Application for Variation of an Environmental Permit

**Agreement No. CE 6/2015 (EP)
West New Territories (WENT)
Landfill Extension – Design and
Construction**

Supporting Document for Variation
of Environmental Permit

Drawing title
LOCATIONS OF PROPOSED ODOUR PATROL

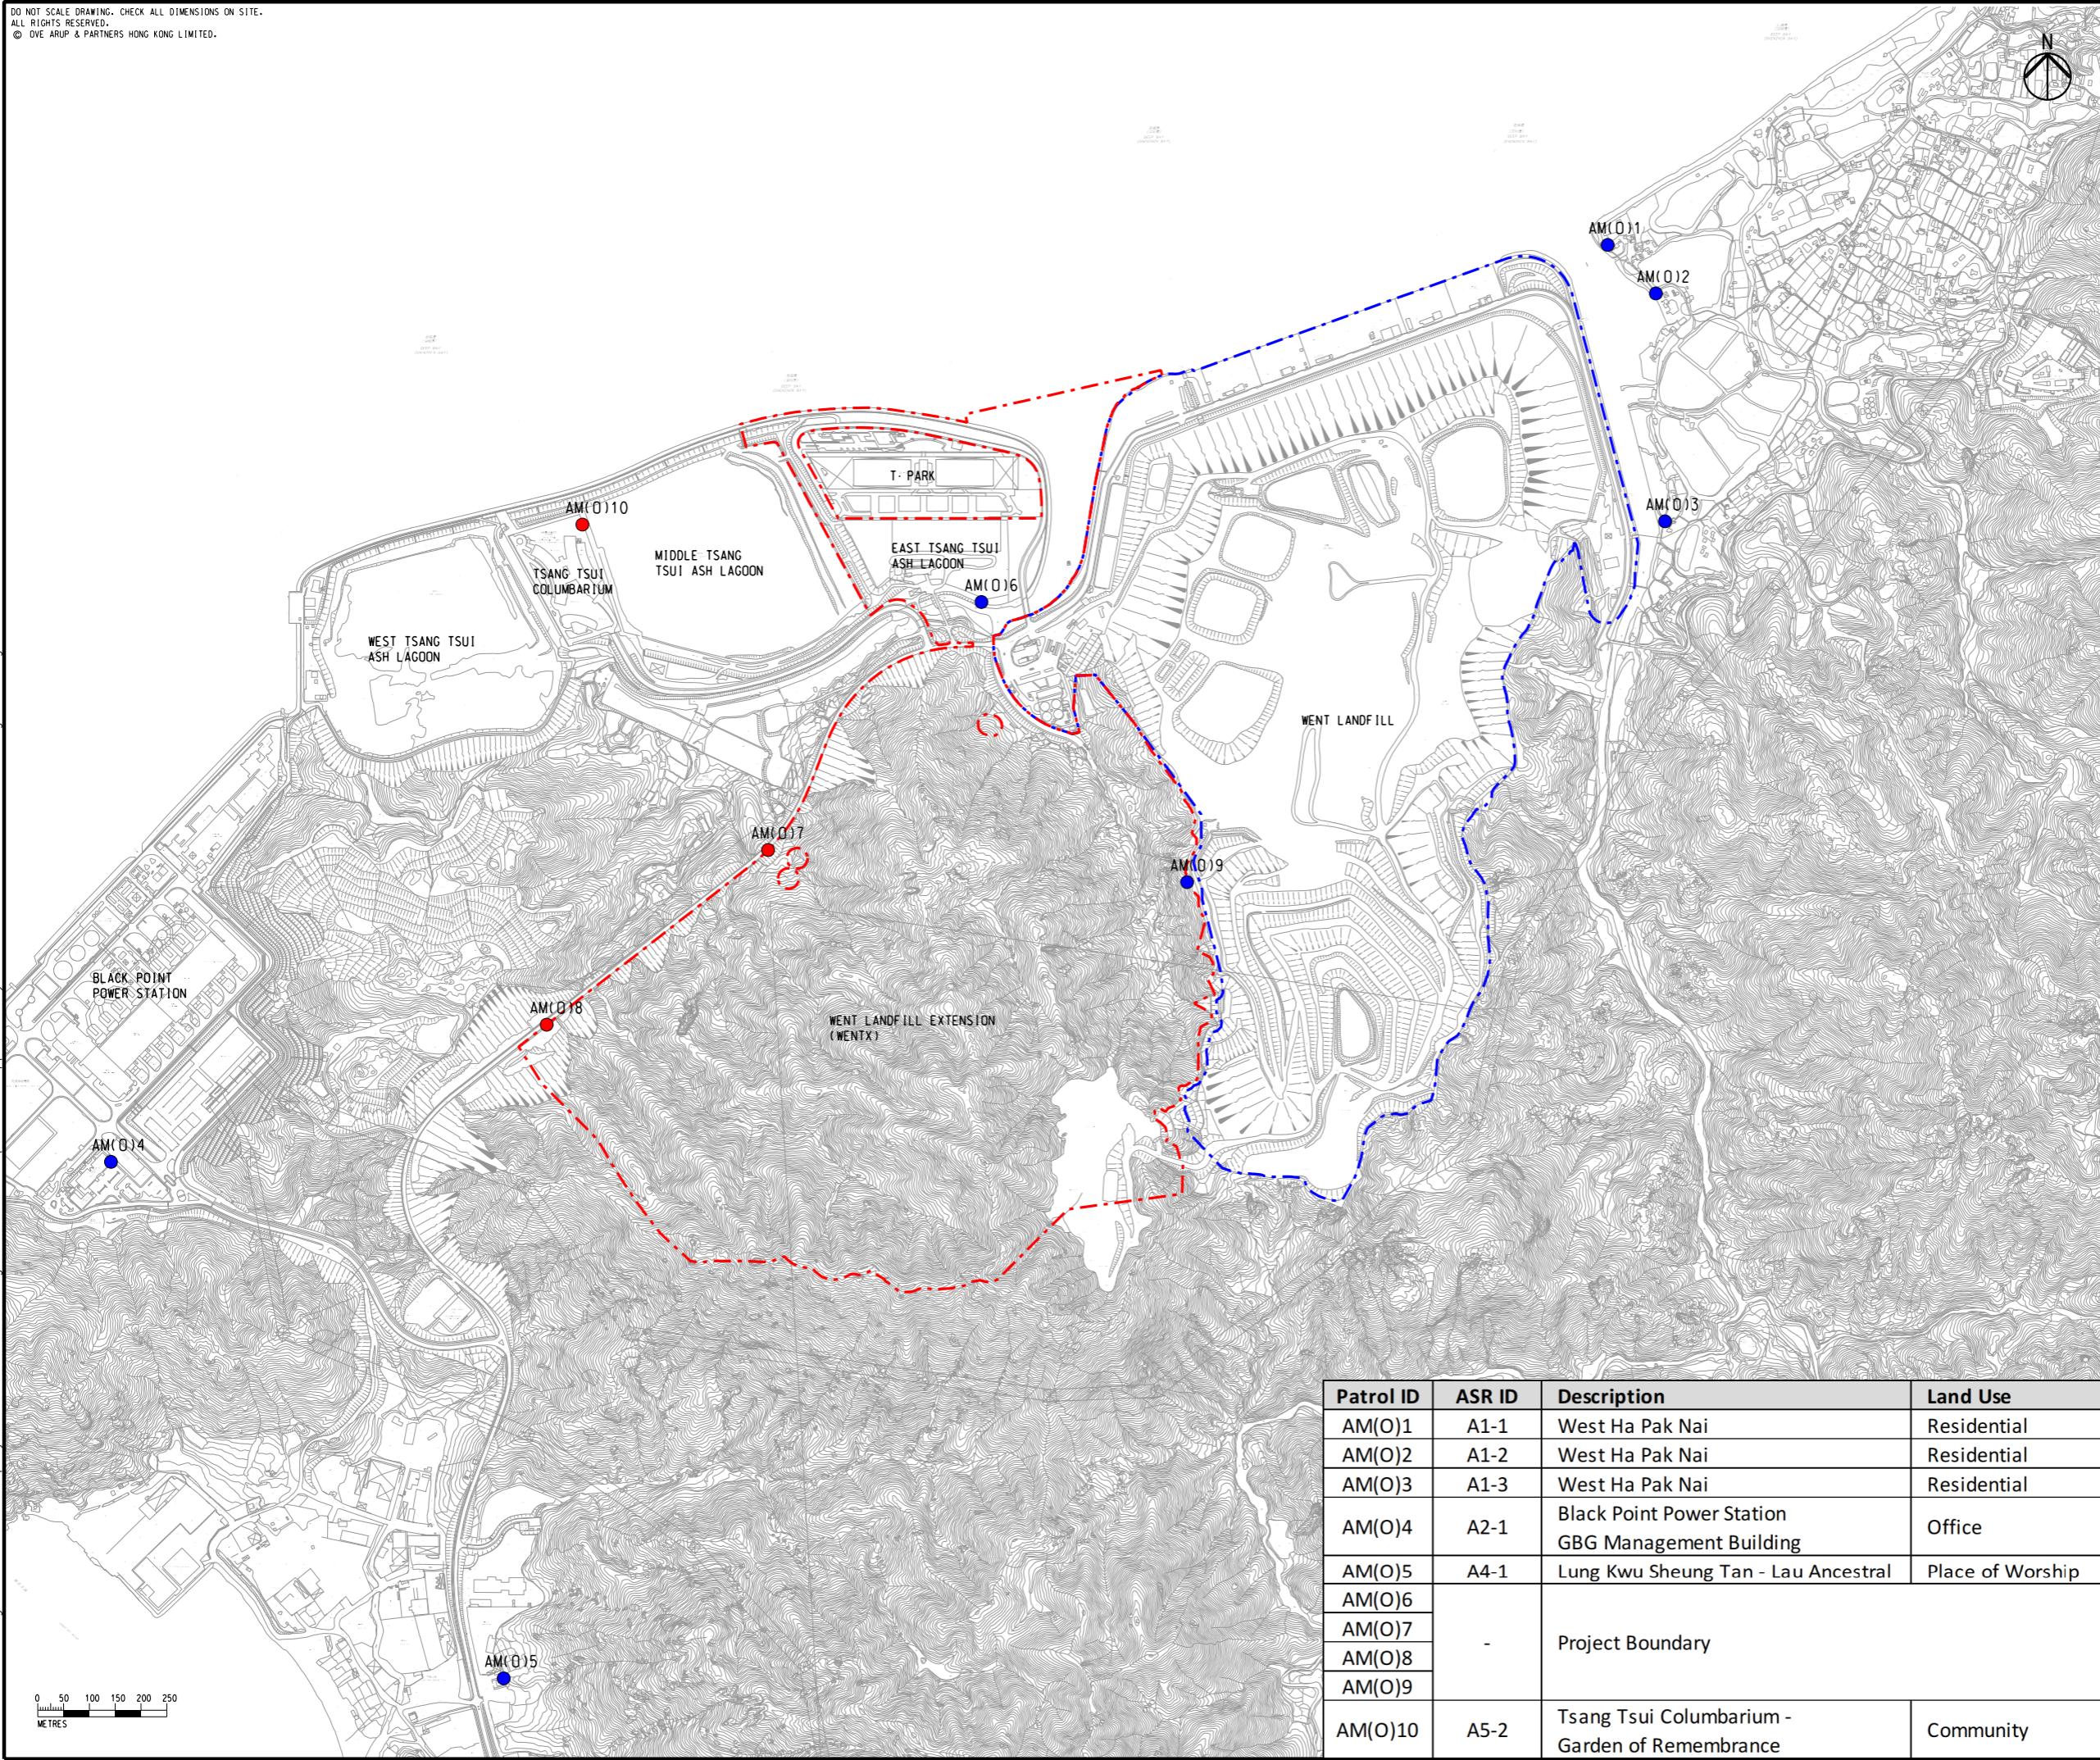
4.1.6 The EM&A programme as specified in the EM&A Manual shall be implemented to detect any odour and rectify the situation in a timely manner. No change on the odour patrol locations as recommended in the approved WENTX EIA is proposed. Due to the reduced waste boundary, two proposed odour patrol locations at the Project boundary need to be adjusted. Additional odour patrol location at Tsang Tsui Columbarium is also recommended (**Table 4.2** and **Figure 4.1**).

Patrol ID	ASR ID	Description	Land Use	Description of Updates
AM(O)7	-	Project Boundary		Given the reduced waste boundary, locations of AM(O)7 and AM(O)8 are adjusted to the northern west side of the tipping area.
AM(O)8	-	Project Boundary		
AM(O)10	A5-2	Tsang Tsui Columbarium - Garden of Remembrance	Community	A5-2 is a new ASR within 500 m of the Project and located closer to the Project boundary compared to A5-1. Hence it is added as patrol location.

Drawing title
LANDFILL CONSULTATION ZONE

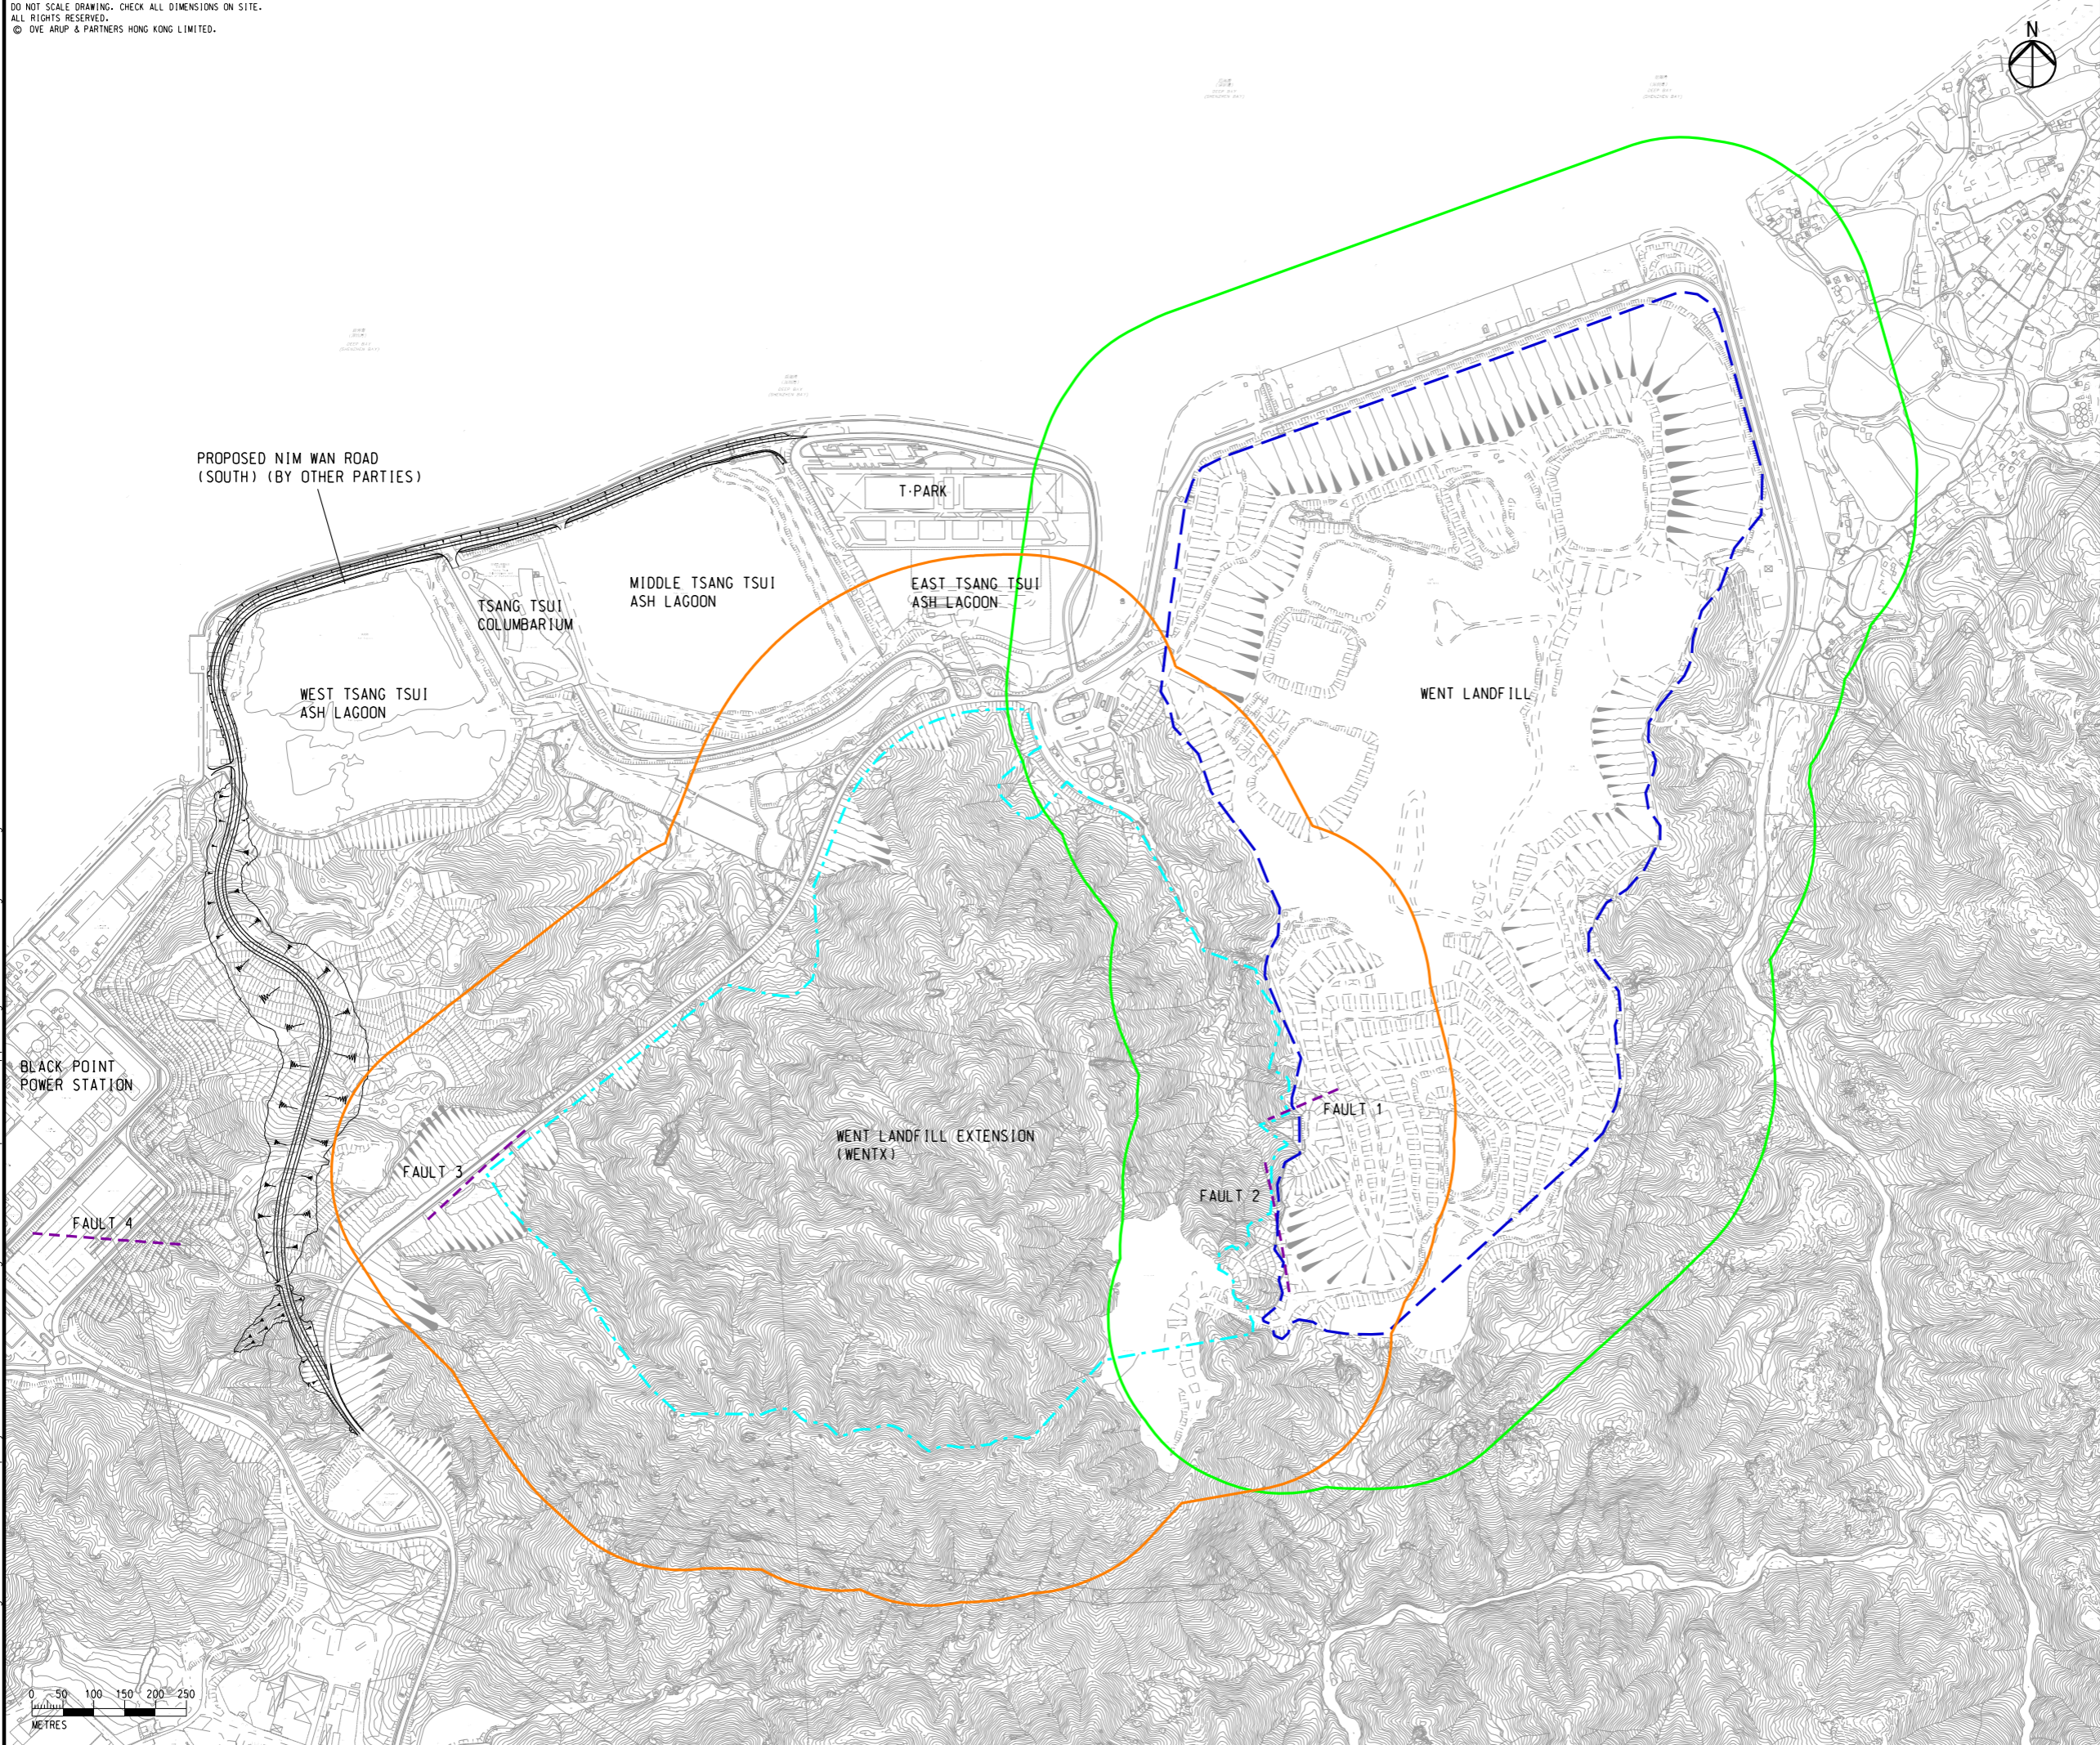
- 9.1.1** Due to the reduced size of waste boundary, the extent of 250 m consultation zone has been revised. All the receivers outside WENTX will no longer fall within the 250 m consultation zone of the WENTX (**Figure 9.1**). Potential landfill gas (LFG) hazard impact is therefore not anticipated.
